CABINET MEMBER FOR HIGHWAY MANAGEMENT 23 FEBRUARY 2023

RADLEY: KENNINGTON ROAD & WHITES LANE – PROPOSED PEDESTRIAN & CYCLE CROSSINGS AND SHARED USE FOOTWAY / CYCLETRACK

Report by Corporate Director, Environment and Place

GENERAL ARRANGEMENT SHEET 1

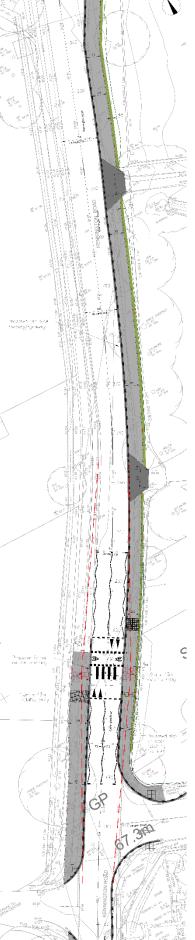
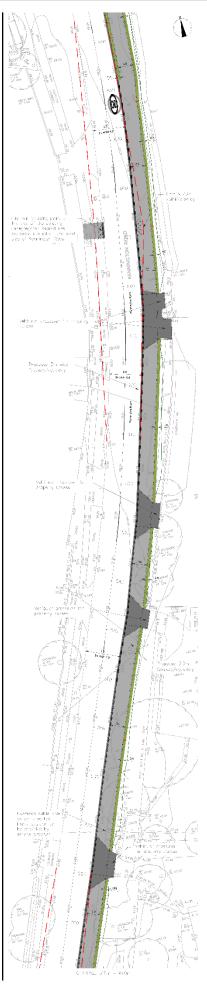
The drawing shows no white lines proposed for the shared use track. There should be: -

- A white line by the kerb where there is no 0.5m grass margin, to help determine where the
 edge is when riding in the dark. Kerbs/cycle track edges can be hard to see when being
 dazzled by oncoming car headlights after dark. Night time commuting lasts over 4 months of
 the year.
- Give way lines for private driveways where they meet the cycle track (Radley entrances are mentioned separately below).
- Some pedestrian/cycle markings at ends/periodically to show shared use.
- Some lines (or signs) to show where cycling is no longer permitted, ie where it changes
 from shared use to pedestrian use only. "Cyclist Dismount" signs MUST not be used, they are
 counter to current guidance.

Tree roots outside Halfway Cottages. Approx 1000 - 1010m point, the house holder has planted some trees just inside/outside the garden fence. What are the construction solutions offered here to protect the tree roots?

The tree variety suggest they have been planted by the house owner, so needs consideration. Relocated car parking bay. This is probably 1 car space less than the current layby. The new lay by must allow for at least the same number of cars to help prevent parking on the cycle track. What remedy is proposed to prevent parking encroachment on the cycle track?

Outside Field House/Grangefield House - the plan at the 530m point says the service provider will relocate the "overhead cable pole". "The pole" is in fact 2 poles (one vertical, one an angled triangulating pole). Has it been checked that relocating the pole is a simple moving a pole, or does the triangulating aspect complicate the issue?

South (Abingdon) bound bus stop near Redrow homes suggests an issue, but the drawing has the bus stop in its old position. It has been relocated north to about 1391m point (so missing cycle users who will turn off to Redrow at about 1388m point. So this should not be an issue.
